**DEVIATION REQUEST** (Attach diagrams, figures, and other documentation to clarify request)

A deviation from the standards of or in Section 2.5.2.F.2 of the Engineering Criteria Manual (ECM) is requested.

VILLAGE AT LORSON RANCH

TRAFFIC EXHIBIT  
PROPOSED ALTERNATIVE  
June 4, 2024

TRAFFIC EXHIBIT  
CORNER REFUGE ISLANDS

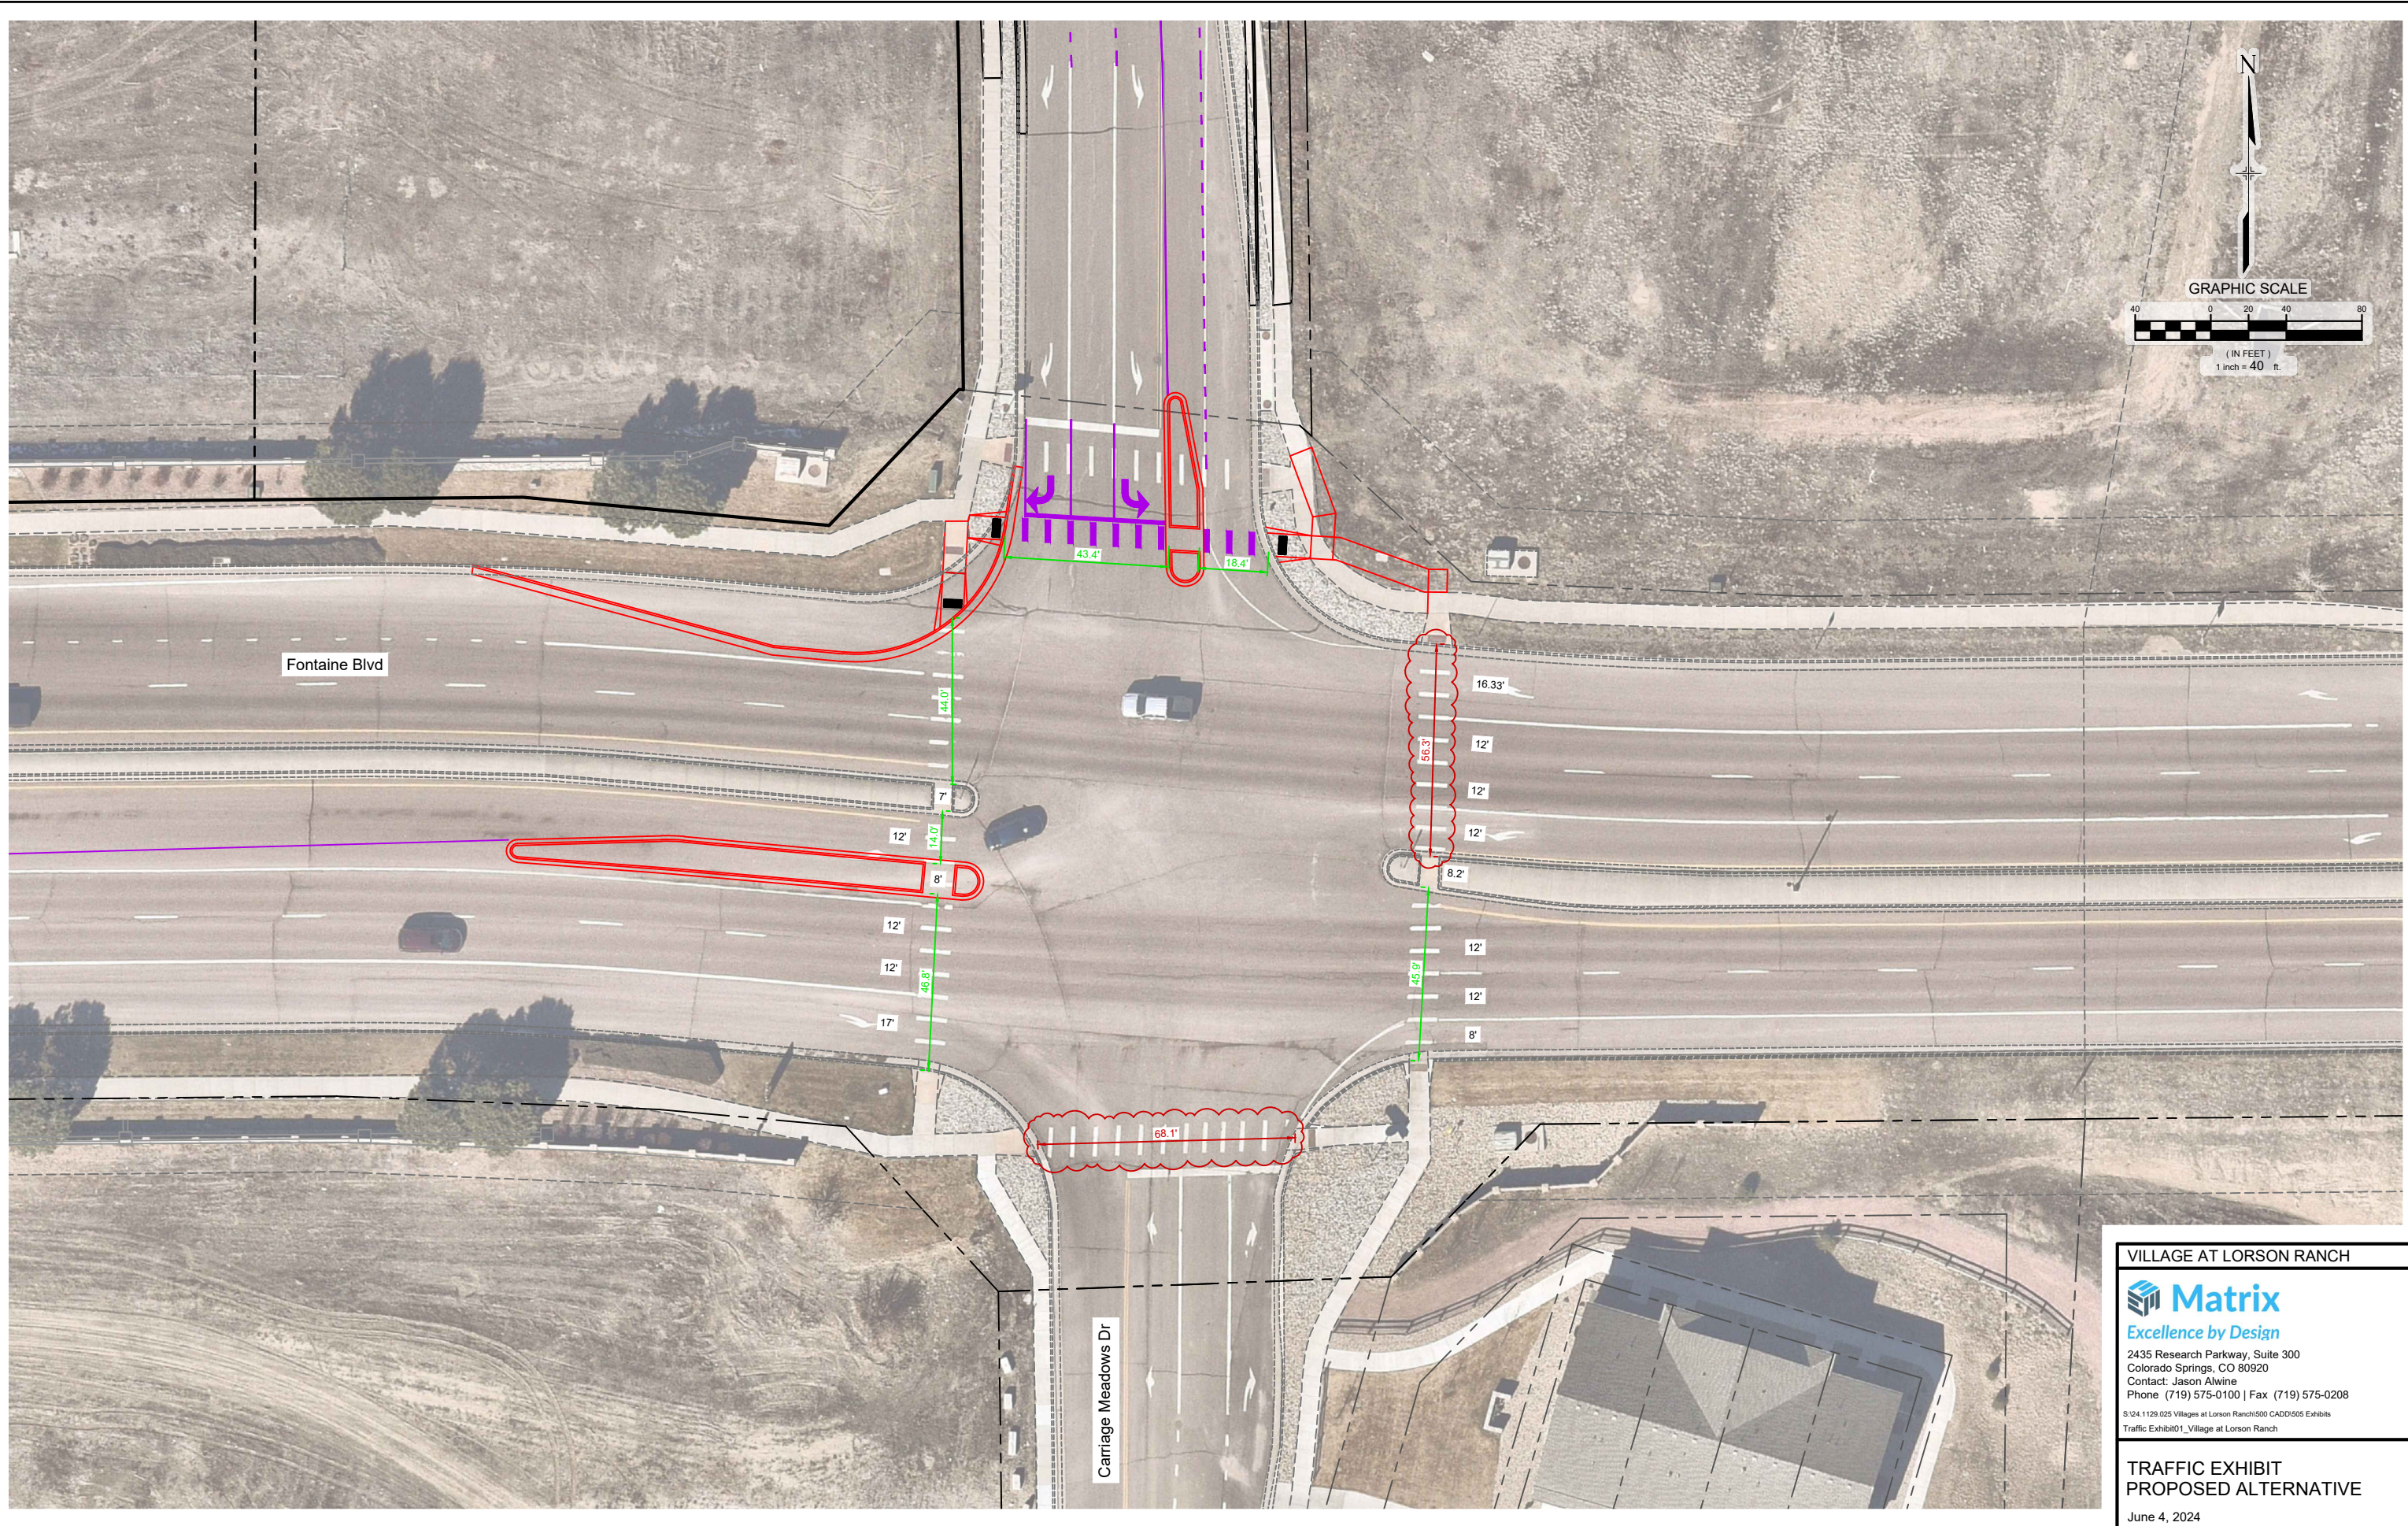
The proposed alternative to the ECM standard is requested because of the considerable amount of modification and expansion to accommodate pedestrian refuge pork chop islands at all 4 sides of the intersection. Modification would include relocation of (2) 6'x12' concrete electric vaults, relocate a 25' long Type R inlet, relocate a 5' long Type R inlet and reconstruct a portion of storm sewer, additional pavement/curb/sidewalk reconstruction and expansion, and ROW taking at 3 of the 4 intersection corners. MVEA has preliminarily indicated that relocation of the 2 vaults could reach the \$300k-\$400k range and they are not sure they could physically do the modification while keeping everyone's lights on in the area.

The proposed deviation is requested because of the considerable amount of modification and expansion to accommodate pedestrian refuge pork chop islands at all 4 sides of the intersection. Modification would include relocation of (2) 6'x12' concrete electric vaults, relocate a 25' long Type R inlet, relocate a 5' long Type R inlet and reconstruct a portion of storm sewer, additional pavement/curb/sidewalk reconstruction and expansion, and ROW taking at 3 of the 4 intersection corners. Addition of corner refuge islands will also make the sight of oncoming traffic from the Carriage Meadows intersection approaches more difficult to see than not installing the corner islands.

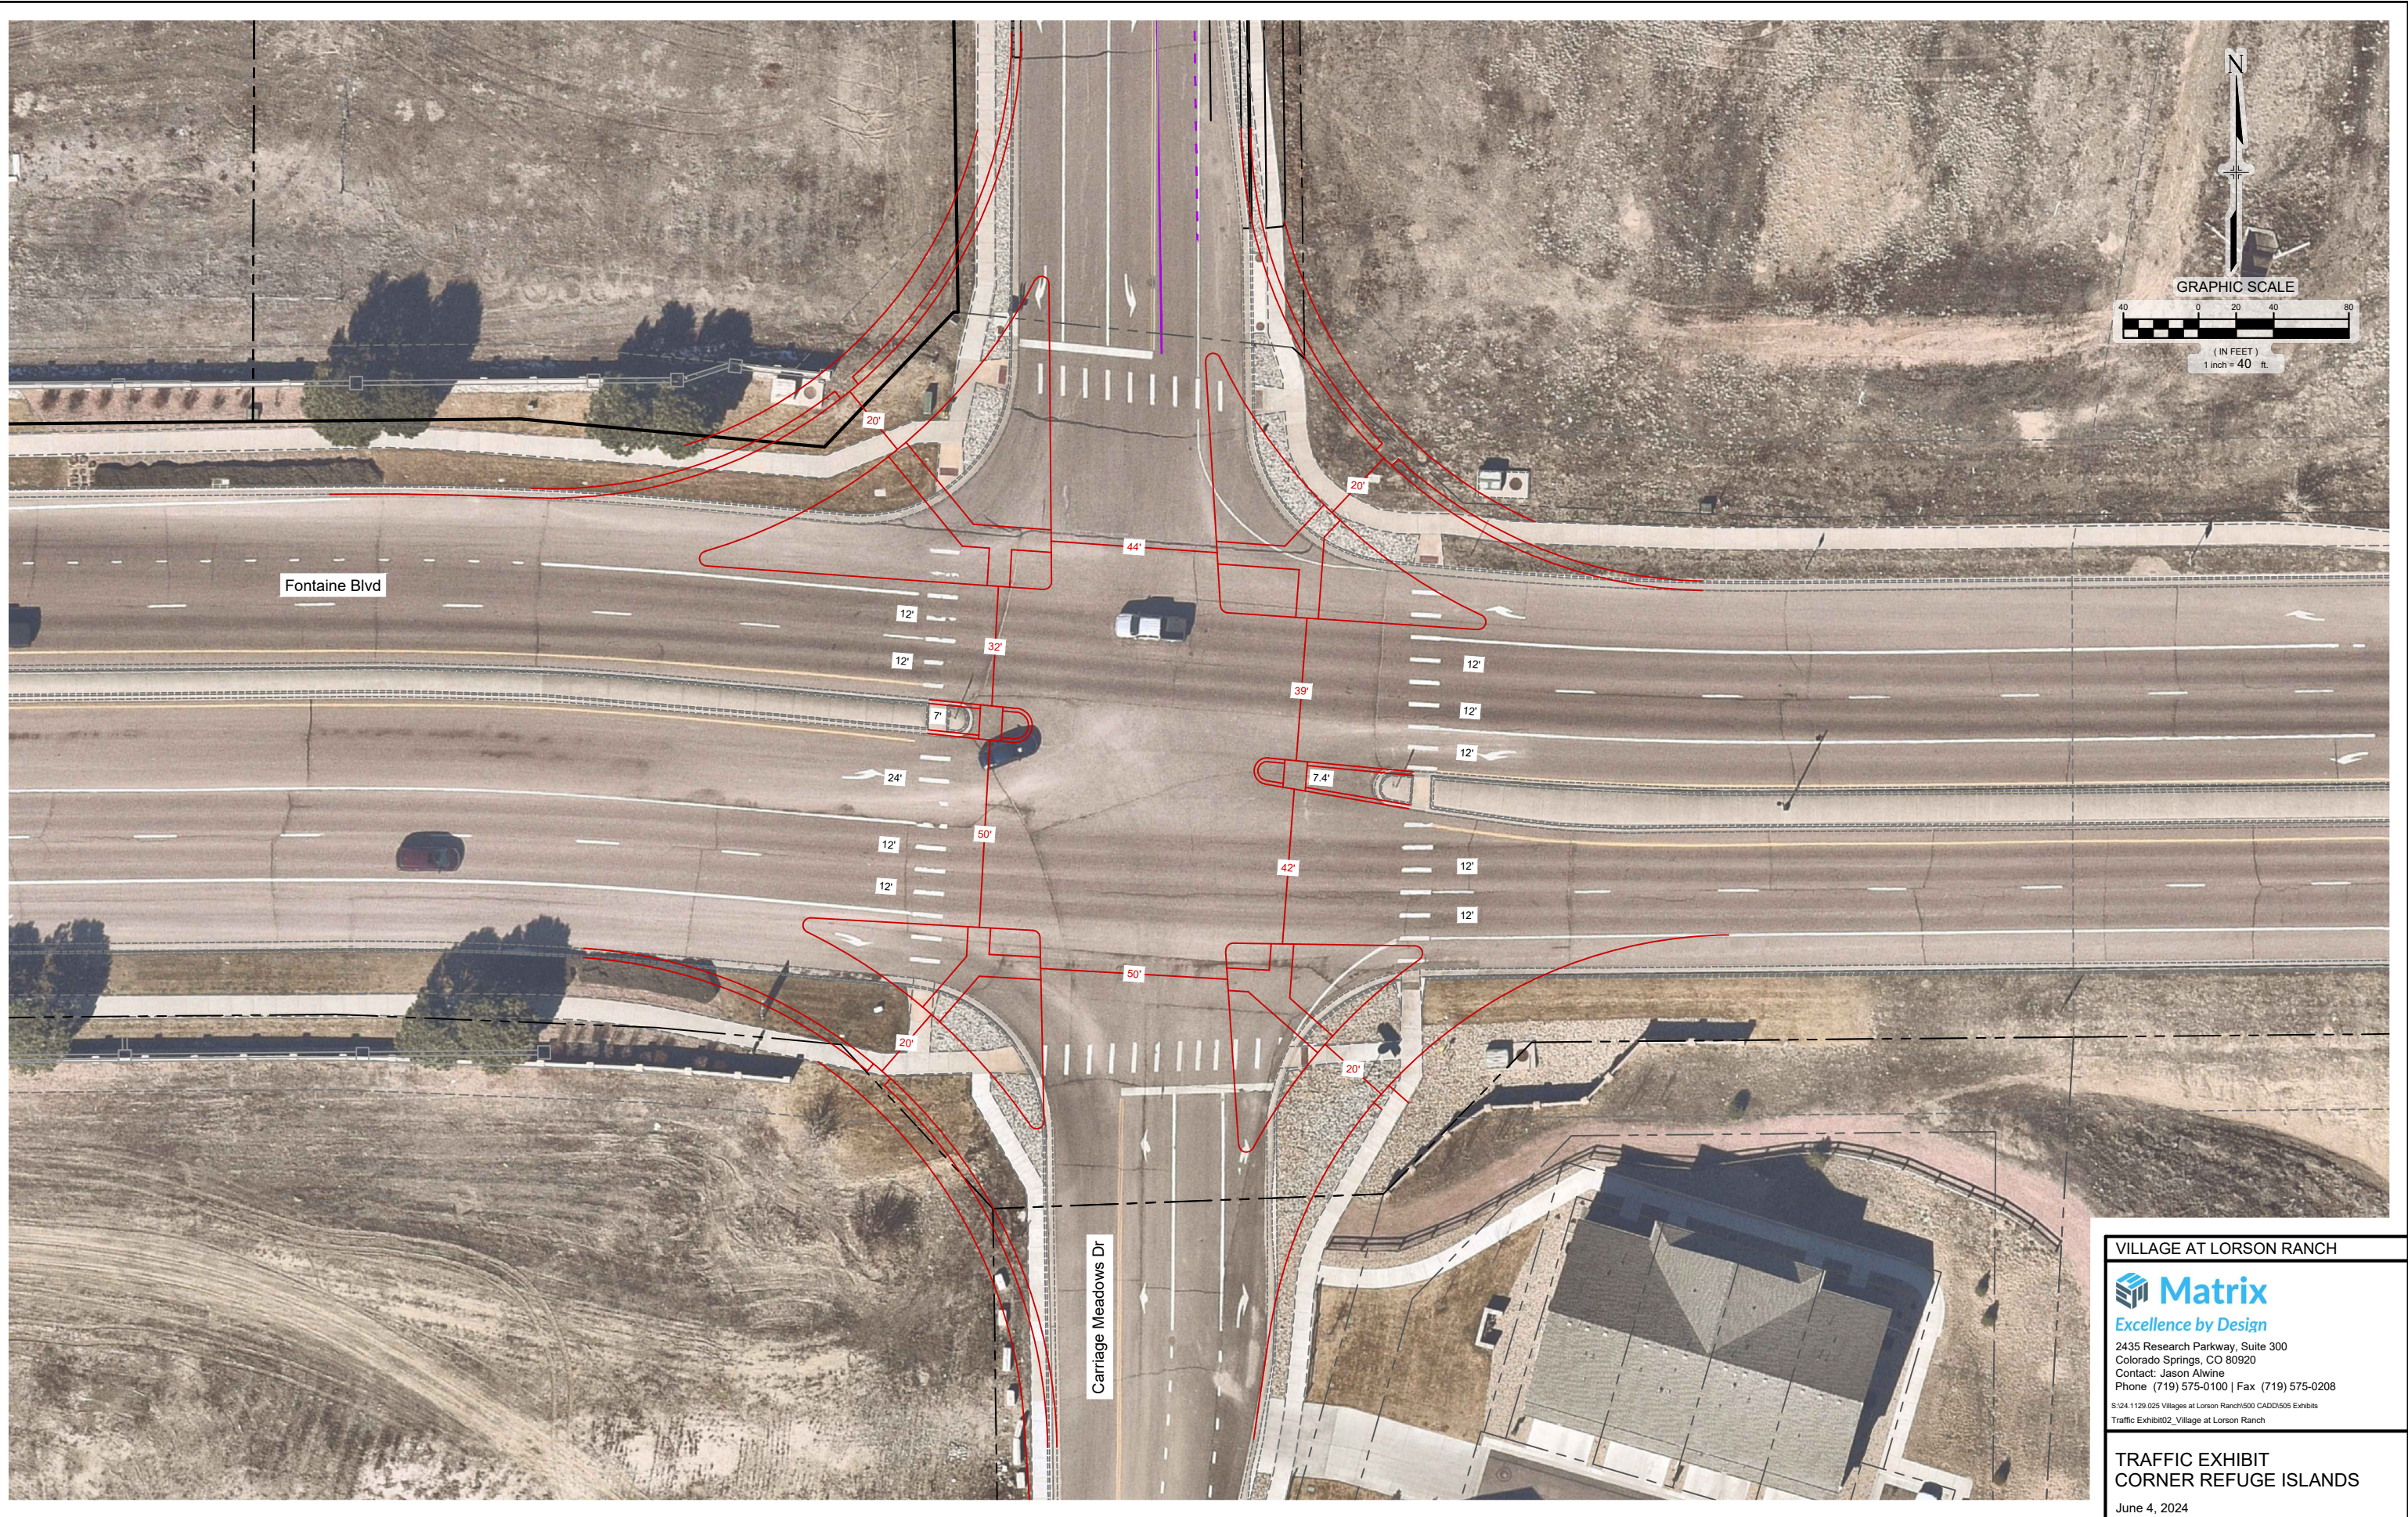
2 of the 4 crossing locations at the intersection of Fontaine Blvd and Carriage Meadows Drive will have a crossing length slightly greater than 48 feet. (See attached exhibit)

Currently, two pedestrian refuge areas exist when crossing Fontaine Blvd. The proposed alternative provides pedestrian refuge at the north, west and east crossings (see attached exhibit). The north and west crossings would meet the 48' or less crosswalk criteria. The east crossing would meet the 48' or less criteria on the south leg however on the north leg would exceed the 48' by approximately 8 feet. At a pedestrian rate of 3.5 feet per second, the extra time required to cross this distance is approximately 2.4 seconds. The south crossing would exceed the 48' by approximately 20 feet. At a pedestrian rate of 3.5' per second, the extra time required to cross this distance is approximately 5.7 seconds. No school sites or parks are near these crosswalks, and we believe the requirement of full pedestrian refuge pork chop islands would be excessive for this specific existing location. Corner refuge islands that will accommodate the WB-67 design vehicle necessary for the Fontaine Boulevard arterial classification will provide large radius turns that imply motorists can accelerate even though there is no receiving acceleration lane. Additionally, the configuration of the large radius corner refuge islands will make it difficult for motorists executing right-turns out of the Carriage Meadows intersection approaches to view oncoming vehicles because of the orientation of their vehicle at a greater than 90-degree angle to the direction of oncoming traffic.
